**Addendum No. 4**  
**Date: July 26, 2024**

**NEW SOFTBALL COMPLEX AT  
DAPHNE HIGH SCHOOL  
FOR THE BALDWIN COUNTY BOARD OF EDUCATION  
DAPHNE, ALABAMA**

**MCKEE PROJECT NO. 23.199**  
**ALABAMA DIVISION OF CONSTRUCTION MANAGEMENT NO. 20240198**

TYPICAL SCOREBOARD SUPPORT  
COLUMN & FOUNDATION DETAIL

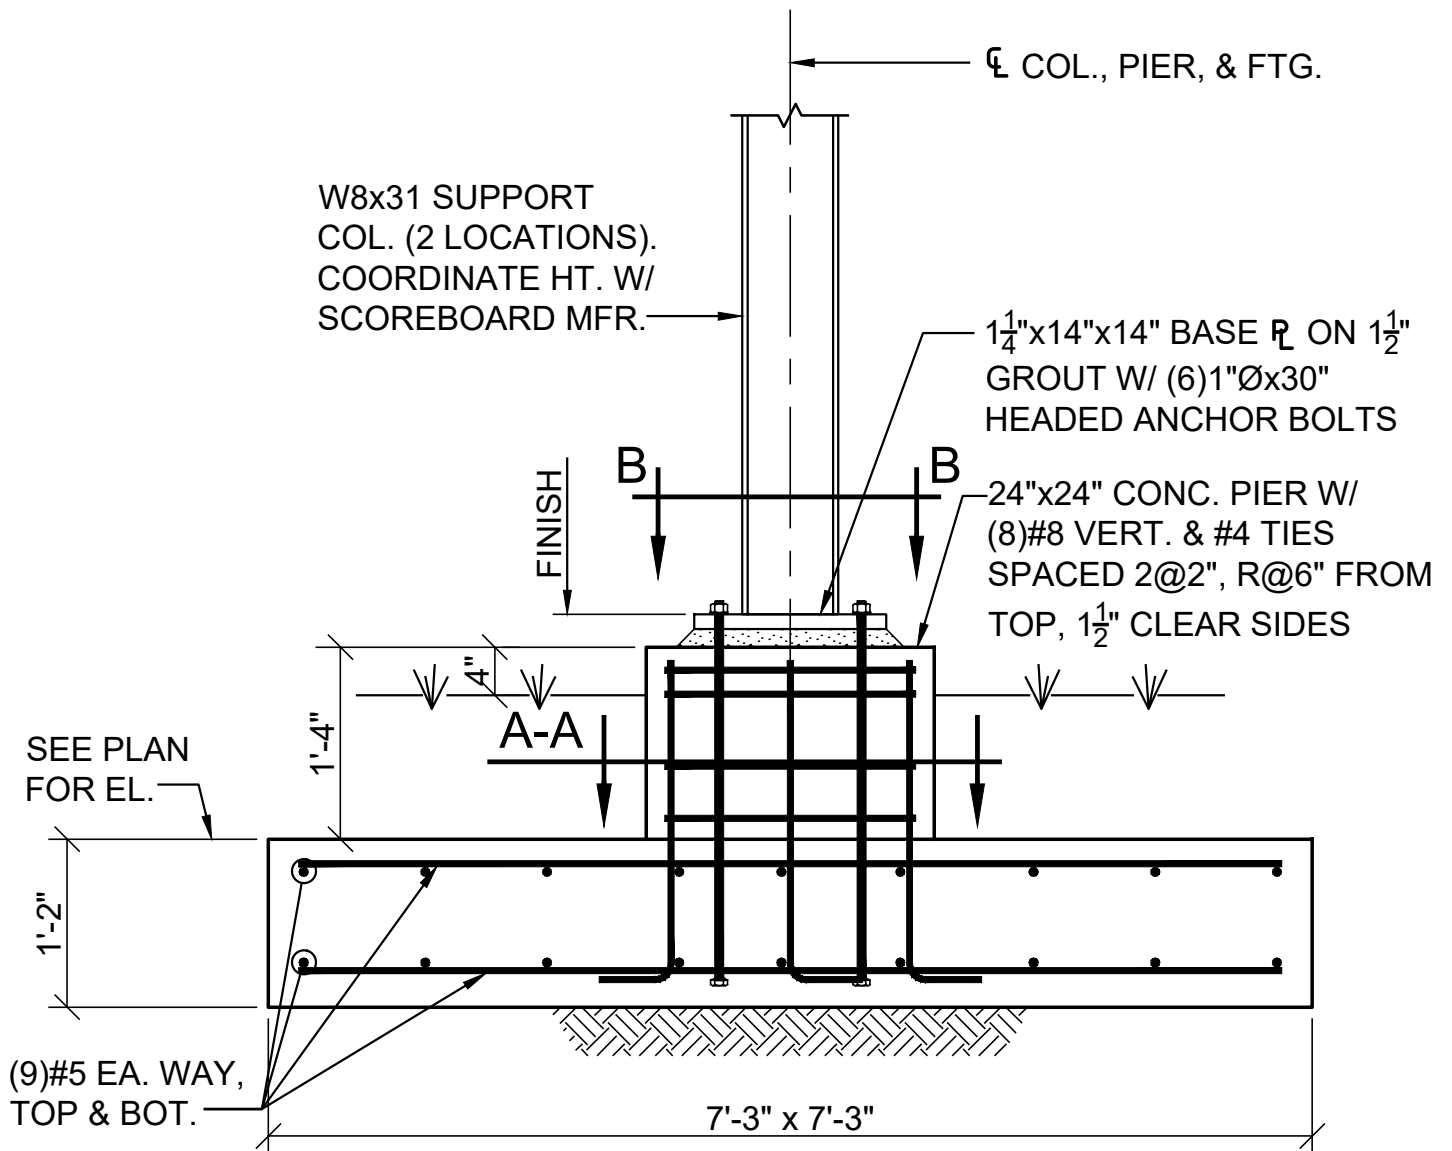
**Question 14:** Per reviewing the drawing set and project manual dated 6/4/24, there are no details or specifications identifying the dimensions of the foundations for the scoreboard or light poles. Please provide details showing dimensions and depth from finished grade of the concrete footings that support the scoreboard and light poles.

14. Sheet **C6.0 (Revised 06.19.24)**, herein.
15. Sheet **C6.1 (Revised 06.19.24)**, herein.
16. Sheet **TYPICAL SCOREBOARD SUPPORT COLUMN AND FOUNDATION DETAIL** herein.

**Answer 14:** Scoreboard foundation will be included in next addendum. Light pole foundation design is by provider.

SHEET NO. : **A1.1**

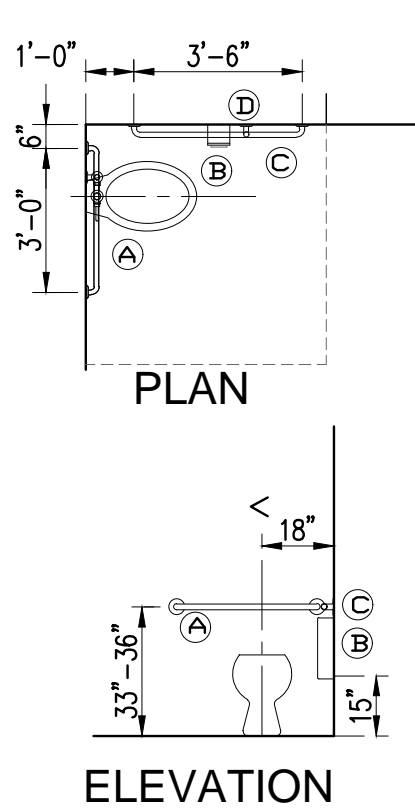
**Question 12:** Sheet A1.1 has a specialties legend, but the floor plan only identifies FEC. Please provide floor plan identifying other specialties noted.

17. Sheet **A1.1 (Revised 07.26.24)**, herein.
18. Sheet **A4.2 (Revised 07.26.24)**, herein.
19. Sheet **P1.1 (Revised 07.10.24)**, herein.
20. Sheet **P1.2 (Revised 07.10.24)**, herein.

**Answer 12:** Will be included in addendum.
